**Agenda
Planning Commission
Council Chambers
Wednesday, January 15, 2014 - 7:00 P.M.**

**Staff Review of Site Plan/Special Use Application
Parkridge Homes
601 Armstrong Drive**

**Staff Review of Site Plan Application
National Storage Centers – Ypsilanti: Expansion
517-521 Tyler Rd**

Site Plan

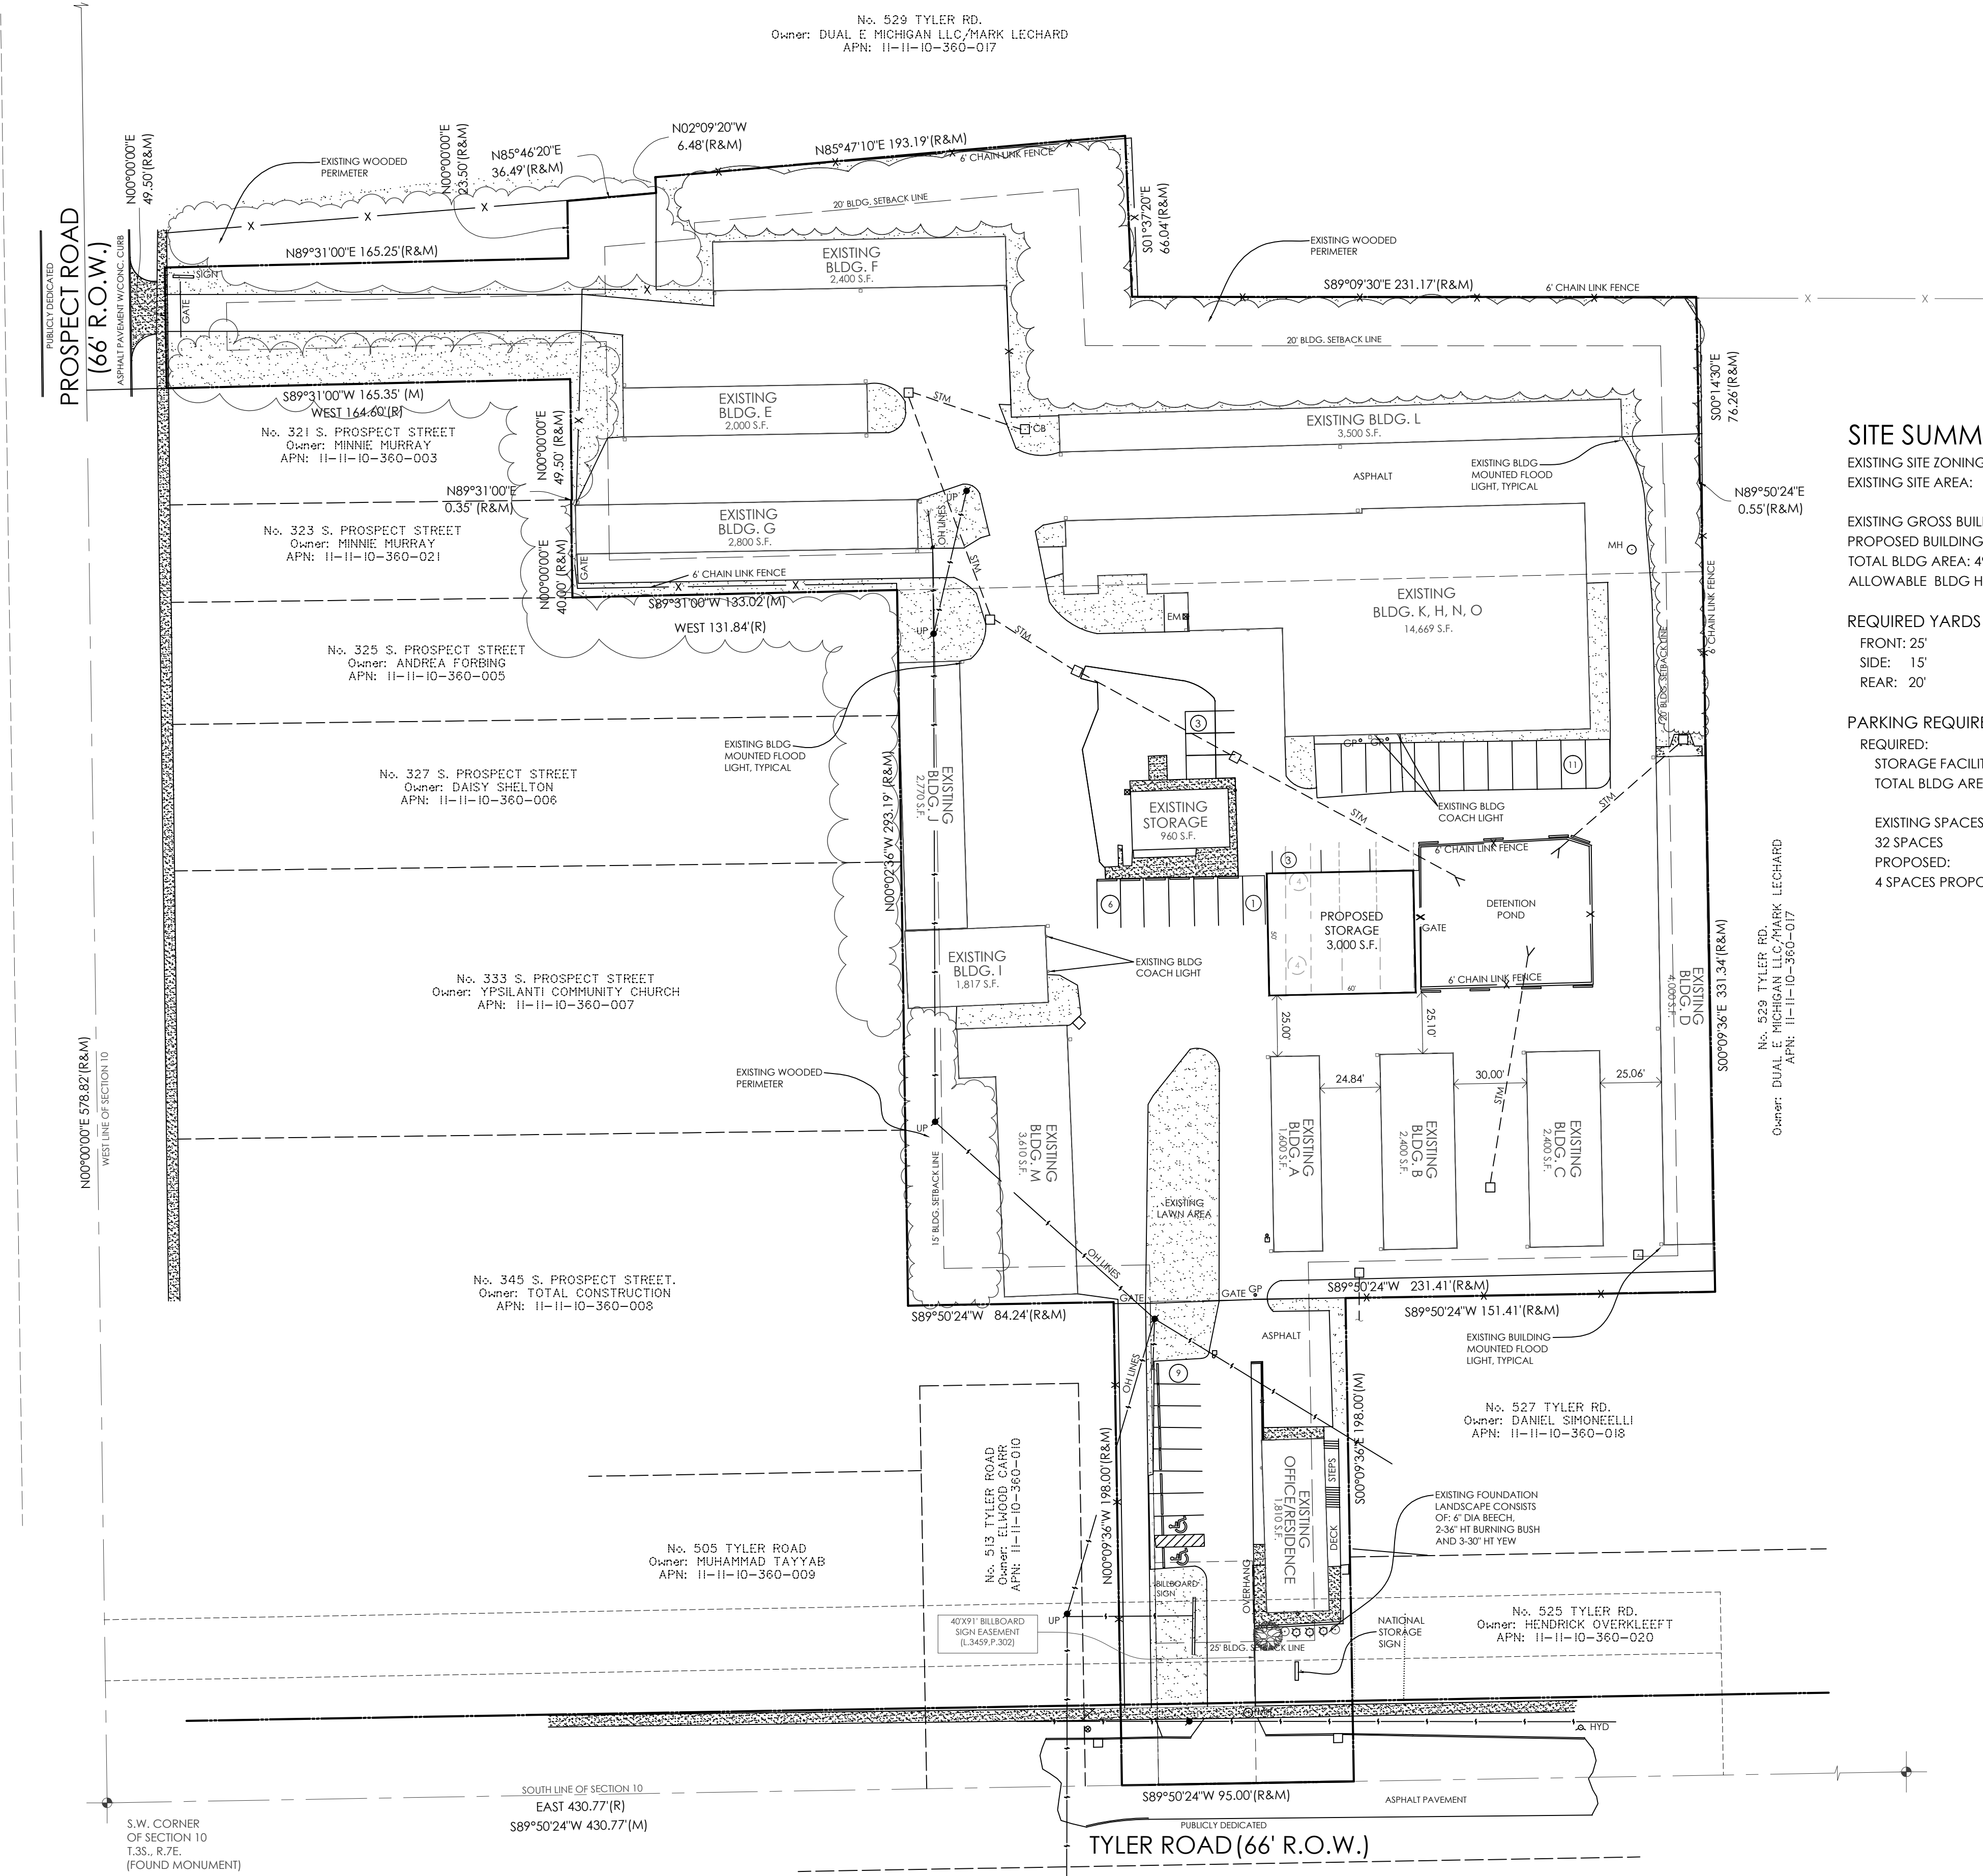
Items to be Addressed: Note height of proposed building on plan.

The planned building will be located adjacent to the detention pond, taking the place of approximately 8 parking spaces. 3 new spaces will be located to the north of the building. Otherwise, the site will remain unchanged.

Items to be Addressed: Planning Commission waivers requested to accept proposed screening between land uses, off-street parking landscaping, foundation landscaping, and in-ground irrigation.

1. Applicant to note on the site plan the height of the proposed building.
